**Economic and Social Council**Distr.: General  
5 August 2020

**World Forum for Harmonization of Vehicle Regulations****Working Party on Lighting and Light-Signalling****Eighty-third session**

**Simplification of lighting and light-signalling UN Regulations:  
UN Regulation No. 150 (Retro-Reflective Devices)****Revised proposal to correct and improve the text of UN  
Regulation No. 150****Submitted by the Informal Working Group on Simplification of  
Lighting and Light-Signalling Regulations\***

Figure A24-II

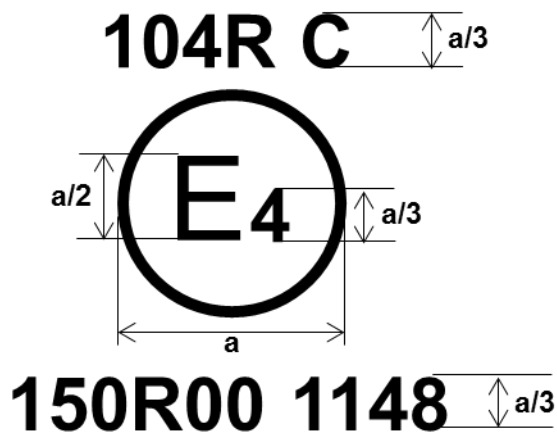
Annex 24, amend to read:

<p><i>Note:</i> The two examples of approval marks, models D and E, represent three possible variants of the marking of a lighting device when two or more lamps are part of the same unit of grouped, combined or reciprocally incorporated lamps.</p>
---

6. Annex 24 has been editorially reorganized and streamlined without changing its contents. The figures have been corrected to provide examples of the approval marks using

Figure A24-III  
 Arrangement example of the approval mark for retro-reflective marking material

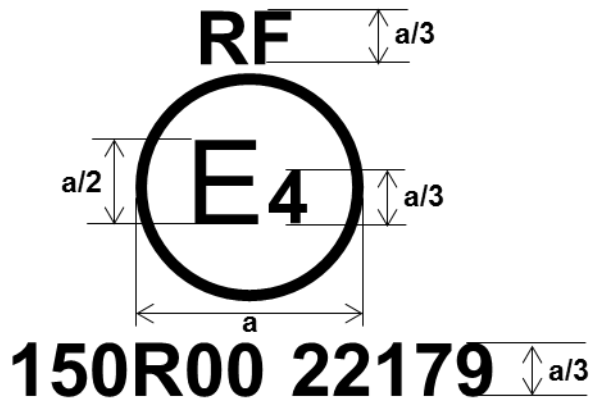
For a = see Table 1

the new UN Regulations. For the size of “a”, the reference was corrected in order to refer to Table 1 instead of Table 2.

Figure A24-IV  
 Arrangement example of the approval mark for rear marking plates and SMV

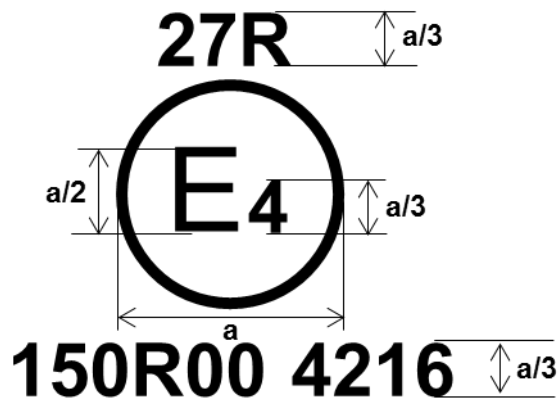
For a = see Table 1
